SIL 707

Service Information Letter

Units Affected: AT37M, AT37P, AT41M, AT41P, AT48M, and AT48P (see attached list)

Shear Plate Bolt Inspection

Figure 1 — Typical Bolt Locations - Number of Bolts Differ with Models

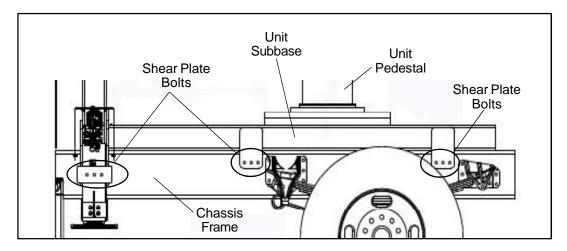
Altec has identified some fasteners that attach the unit to the chassis may not have been tightened to the proper torque value on the affected units. Incorrect torque can result in fasteners coming loose or breaking.

- 1. Position the unit on a level surface, apply the parking brake and chock the wheels. Engage the unit's hydraulic system. Properly set the outriggers.
- 2. Each of the bolts that attach the unit to the chassis (refer to Figure 1) must be checked for the proper torque value. Some chassis components may need to be loosened or removed to allow access to the bolts such as fuel tanks or DEF reservoir.

- 3. Proper torque for the bolts is 220 ft-lb. For the first part of the inspection each fastener should be checked first at 90% of the full torque or 198 ft-lb. Set the torque wrench at 198 ft-lb. and carefully check the torque of each bolt.

- If the torque wrench does not click when carefully tightening a bolt at 90%, ALL of the shear plate mounting bolts must be replaced. The inspection is complete on this unit at this time.

- 4. The second part of the inspection requires each fastener be checked first at 100% of the full torque or 220 ft-lb. Set the torque wrench at 220 ft-lb. and carefully tighten each bolt.

- After tightening to 220 ft-lb, the shear plate mounting bolts inspection is complete on this unit. No bolts require replacement.
- 5. If the shear plate bolts failed the torque inspection in Step 3, the customer can choose to replace the bolts themselves or contact Altec to do the repair. Call 1-877-GO ALTEC (1-877-462-5832) to schedule the work to be done by an Altec service technician or to order the Fastener Kit, part number 990761489, if doing the repair themselves.
